**Meridian Community College,  
Renovations & Additions to Todd Hall**

**ADDENDUM NO. 3**

TO: All Bidders on the above referenced project  
FROM: Davis Purdy Architects, PLLC  
DATE: November 8, 2023  
SUBJECT: **ADDENDUM NO. 3**

Clarifications and revisions to Contract Documents for the referenced project are as follows:

DEMOLITION FLOOR PLAN

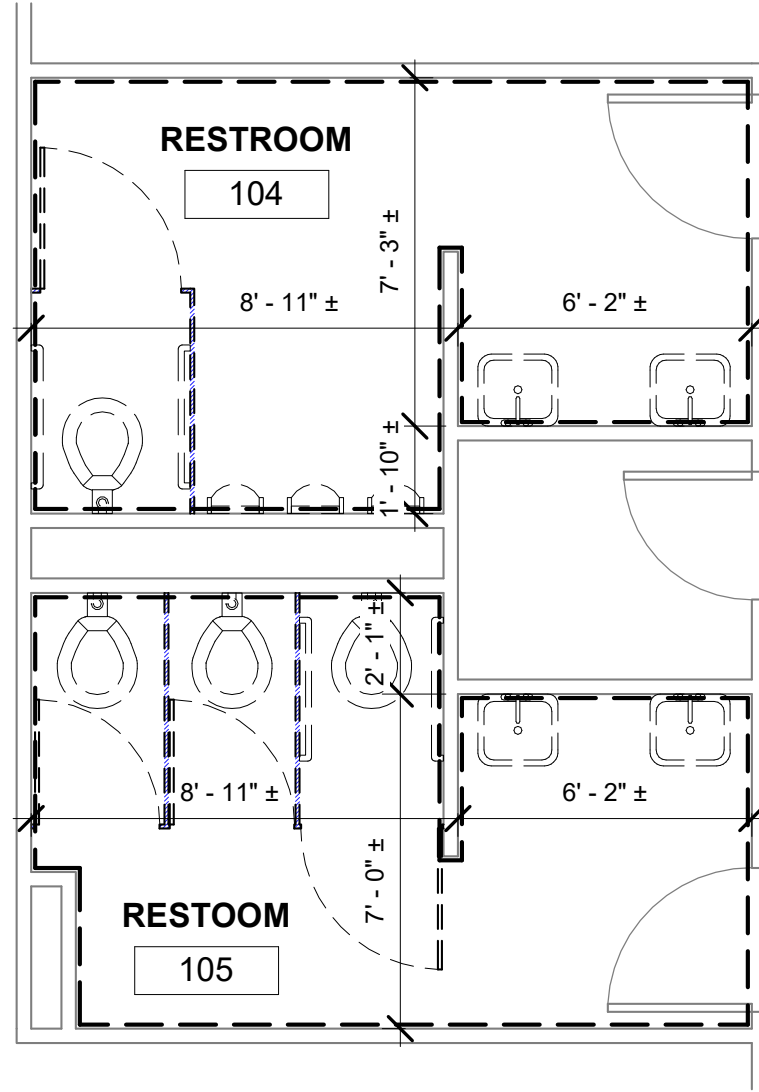
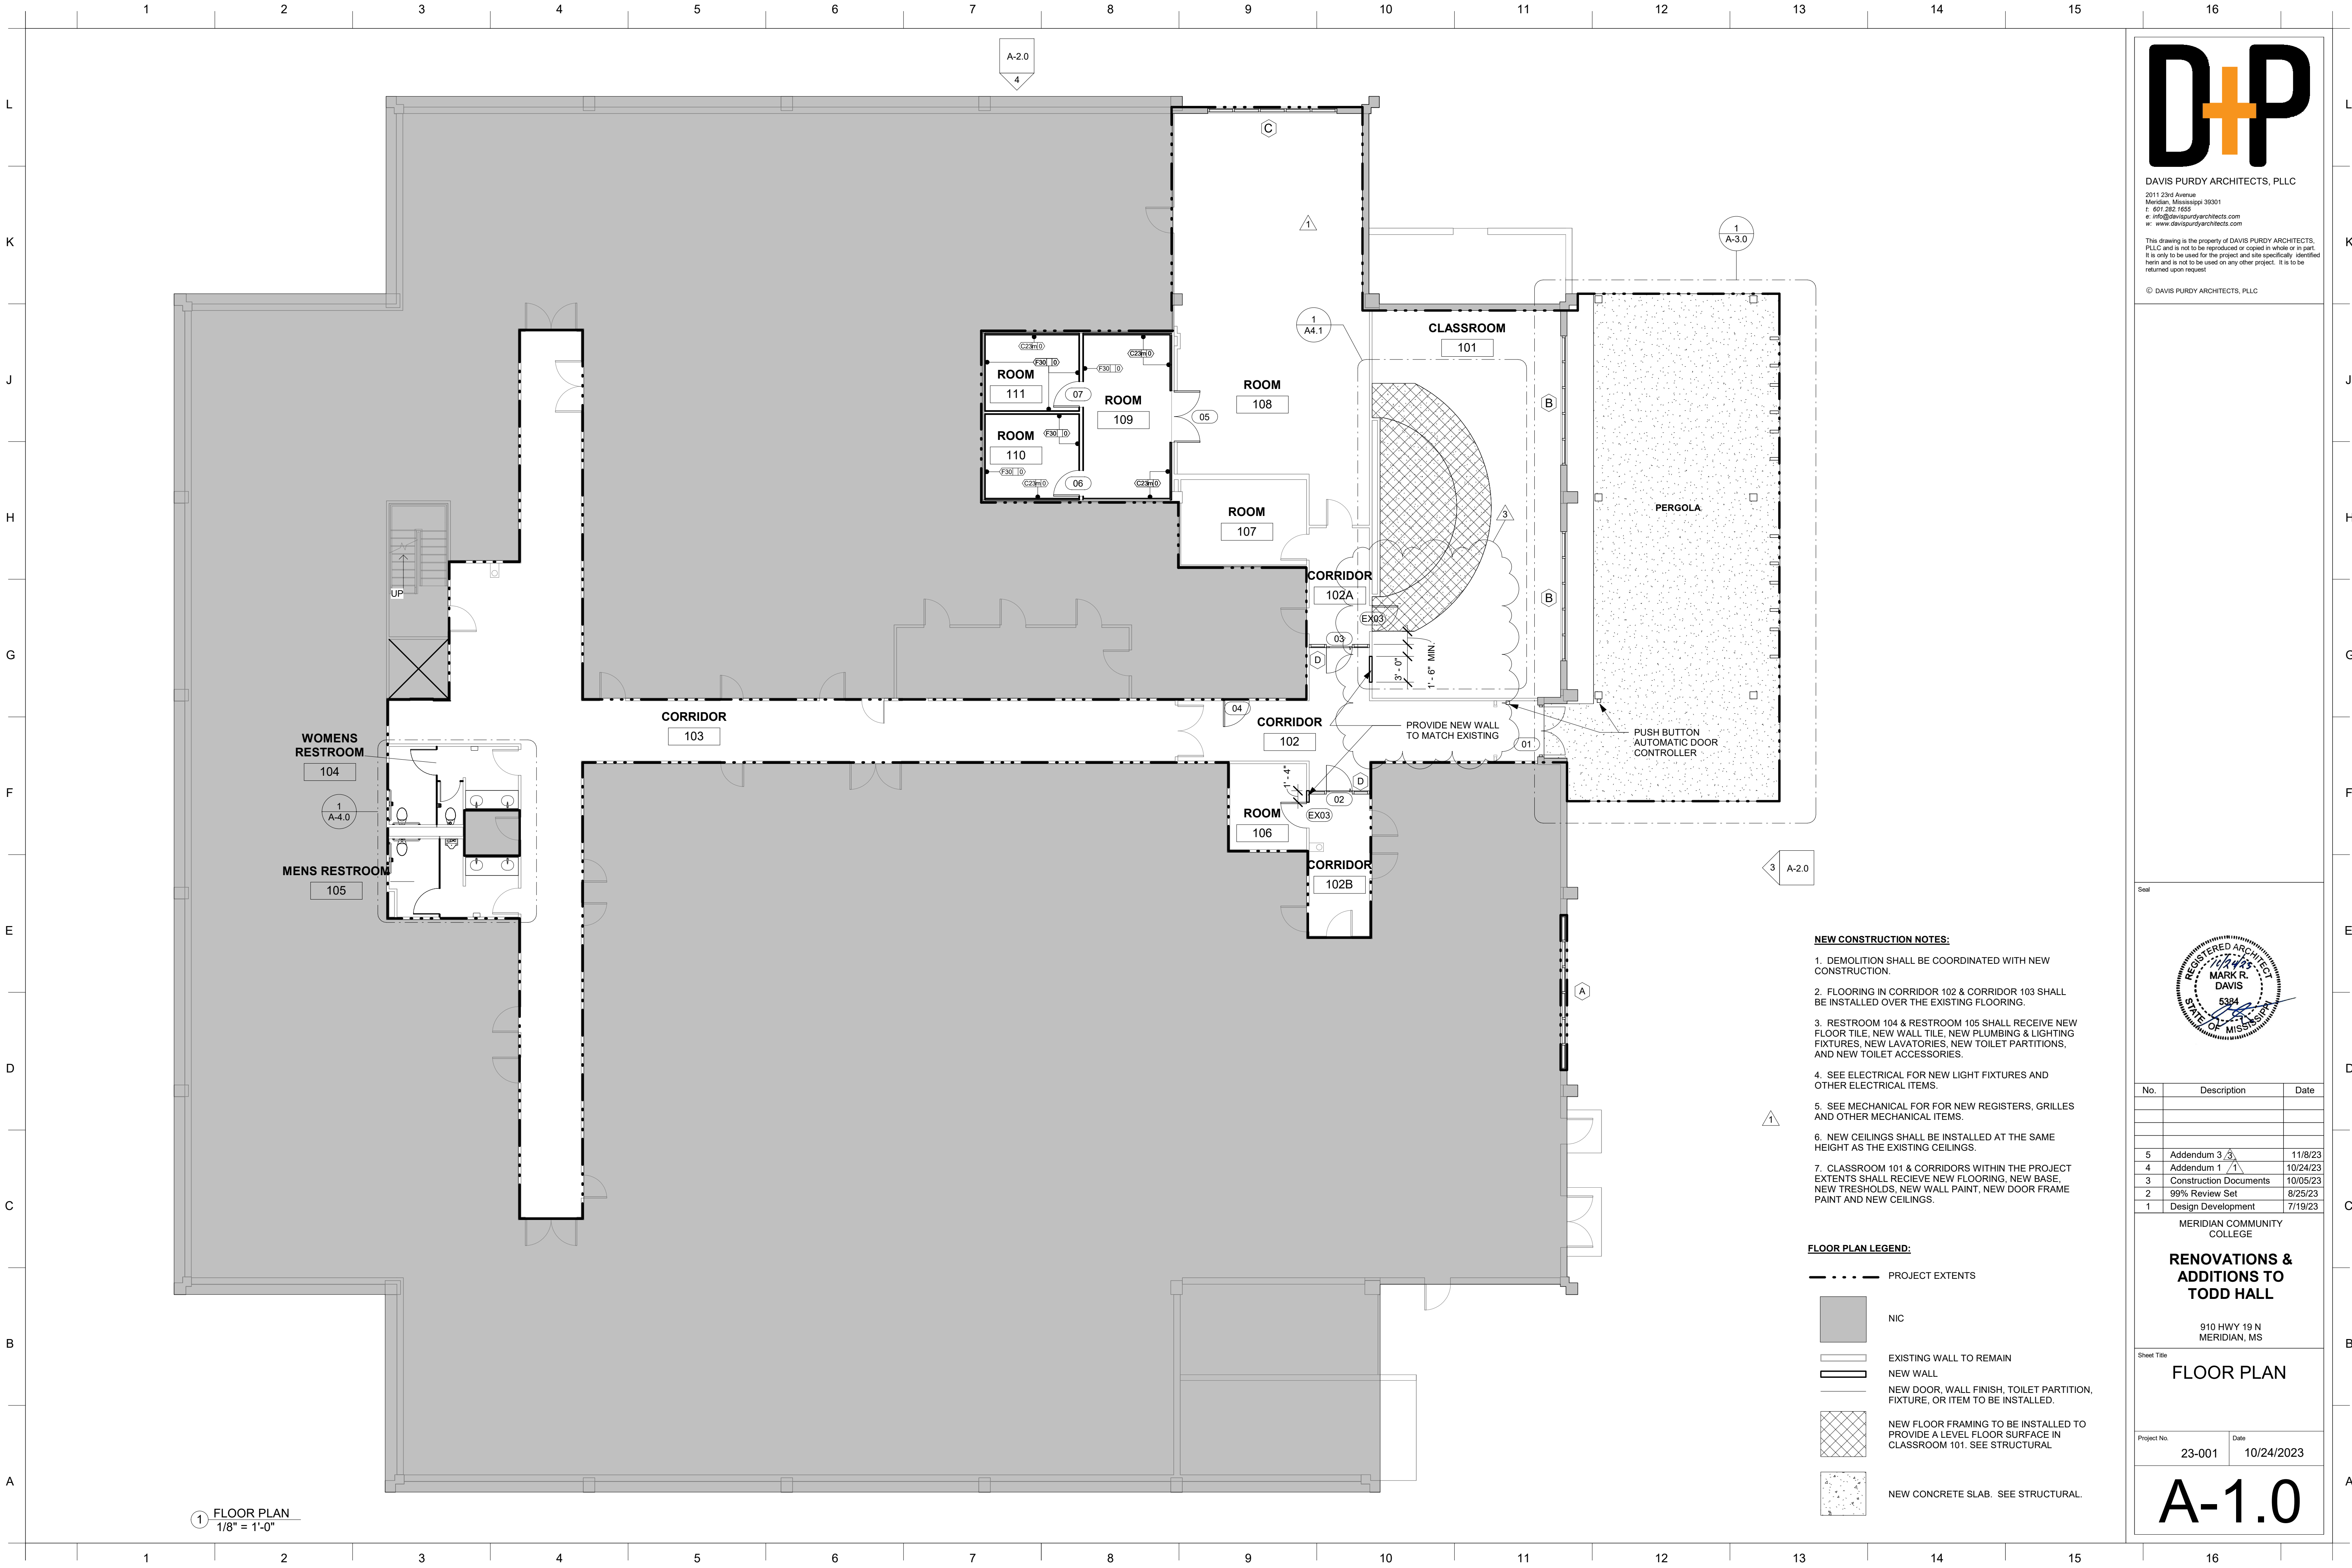
5. **CLARIFICATION:** The existing semi-circle desks in Classroom 101 are to be demolished and not saved. Coordinate with most current drawings.
